Subject: River Bend Station, Unit 1
Docket No. 50-458
License No. NPF-47
River Bend Station Licensing Amendment Request (LAR 2000-26),
"Revision to reactor vessel pressure/temperature (P/T or P-T) limits", and
application of ASME Code Case N640.

River Bend Station (RBS) Technical Specification 3.4.11, "RCS Pressure and Temperature (P/T) Limits."

PROPOSED TECHNICAL SPECIFICATION MARK-UPS

Figure 3.4.11-1 (Page 1 of 1)
Minimum Temperature Required vs. RCS Pressure

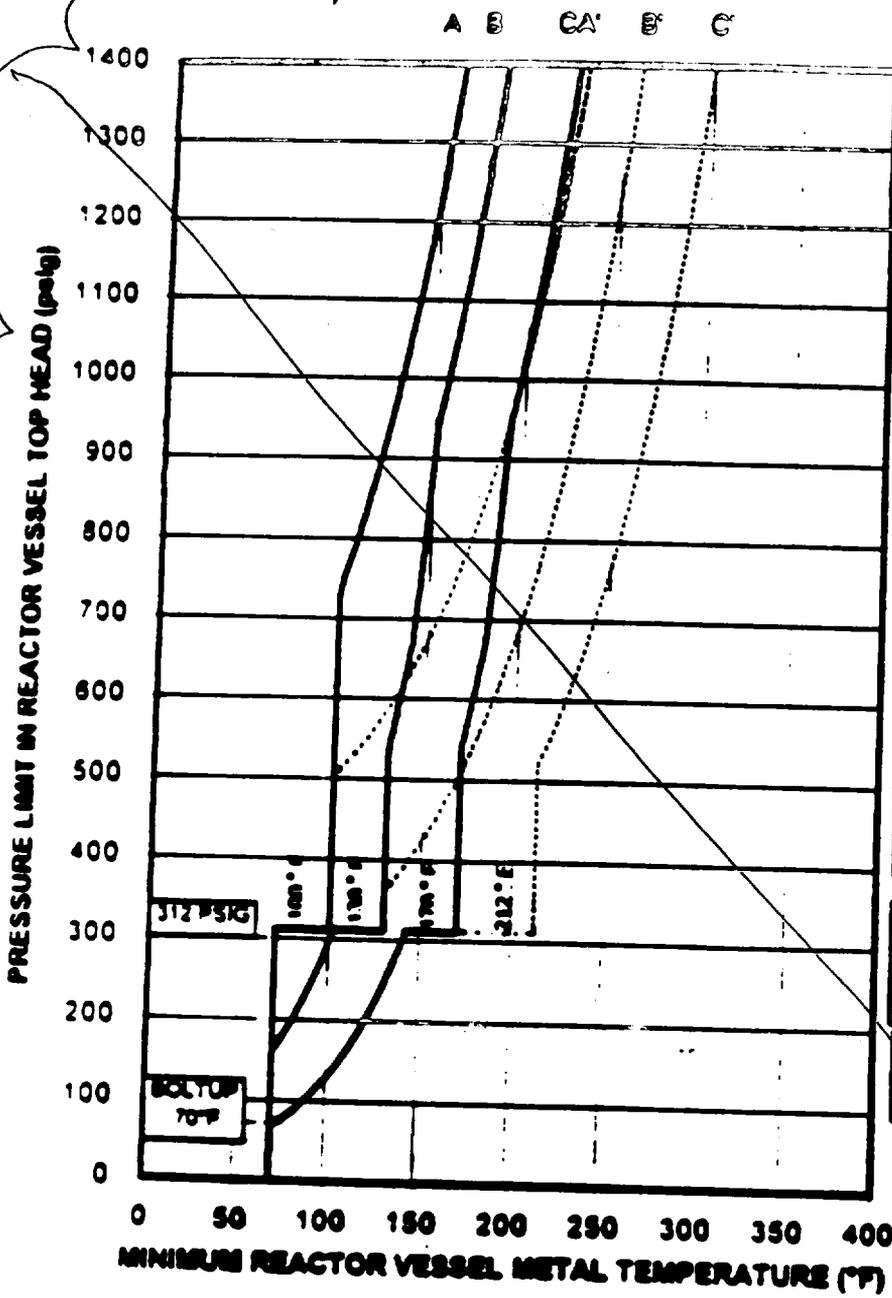
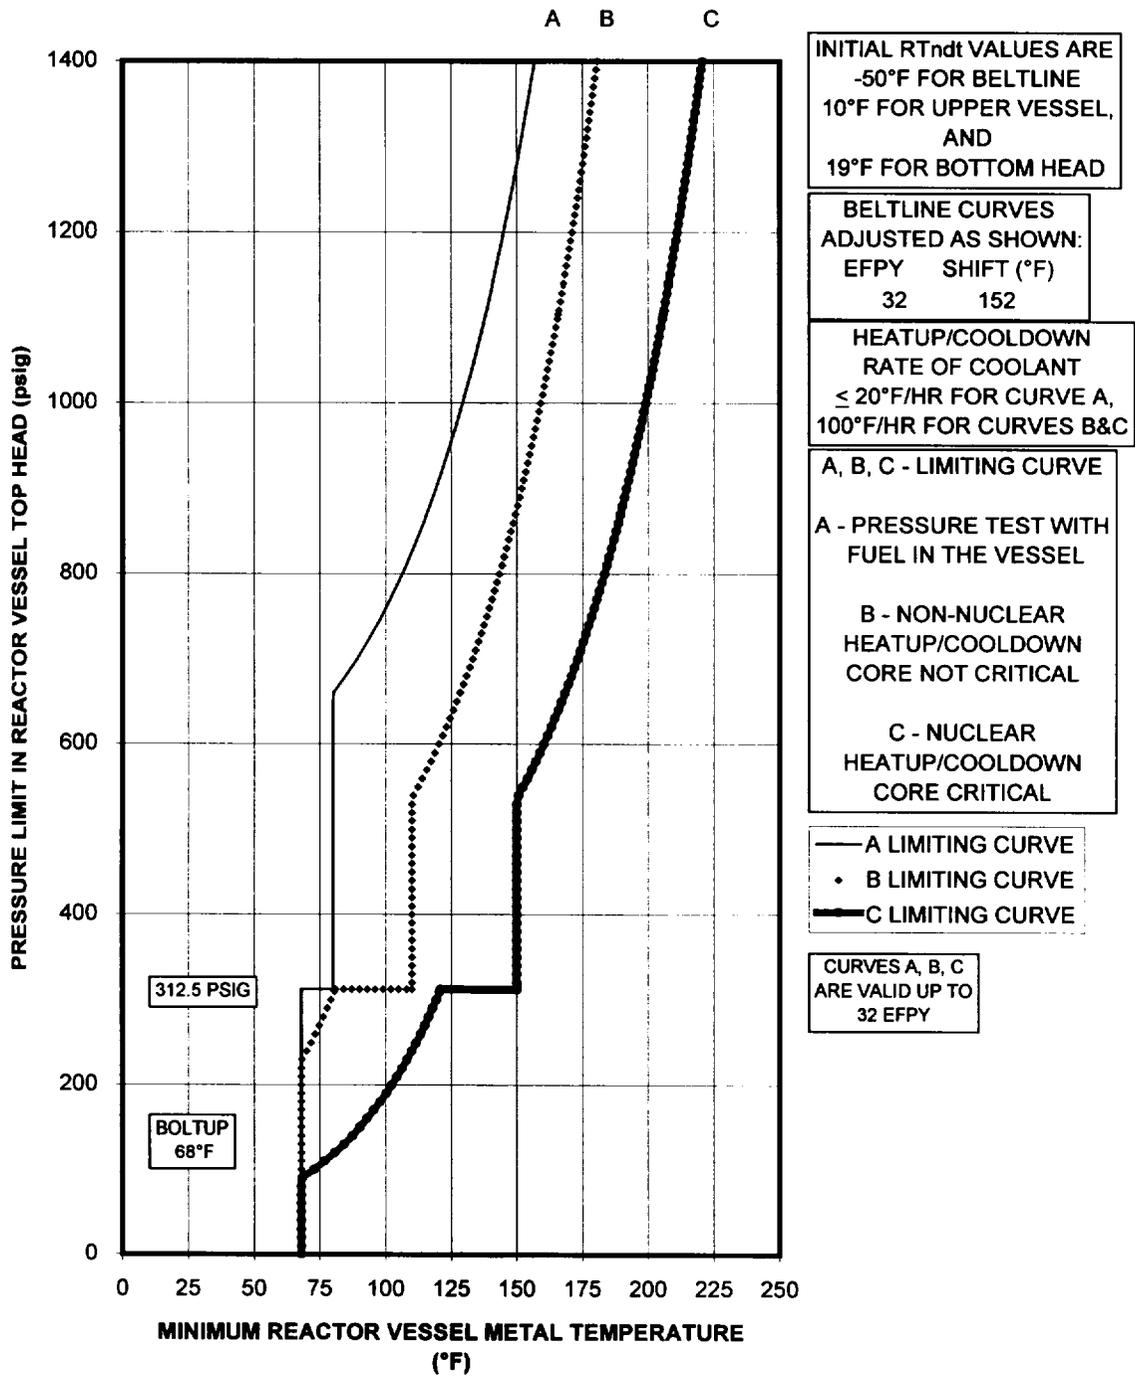
The proposed change contained in this license amendment request is a change to Technical Specification 3.4.11, "RCS Pressure and Temperature (P/T) Limits" to replace figure 3.4.11-1 with a revised figure containing recalculated curves based on new methodology. These new curves for specifying the required temperature limits are established to the requirements of 10CFR50, Appendix G and will continue to ensure margin to the brittle fracture temperature. One of the primary effects of the revised curves is to permit reactor vessel inservice hydrostatic and leak tests to be performed at a lower temperature at applicable vessel pressures. The revised P/T limits (as proposed) are based, in part, on application of American Society of Mechanical Engineers (ASME) Code Case N-640, "Alternative to Reference Fracture Toughness for Development of P/T Limit Curves for ASME B&PV Code Section XI, Division 1." This code case provides alternative methods to those currently approved by the NRC and recognized per 10 CFR 50.60. The use and acceptability of these alternative methods therefore require an exemption from 10 CFR 50.60 requirements. The request for this exemption is further addressed in Attachment 3.

Temperature (P/T) Limits" to replace figure 3.4.11-1 with a revised figure containing recalculated curves based on new methodology.

INSERT
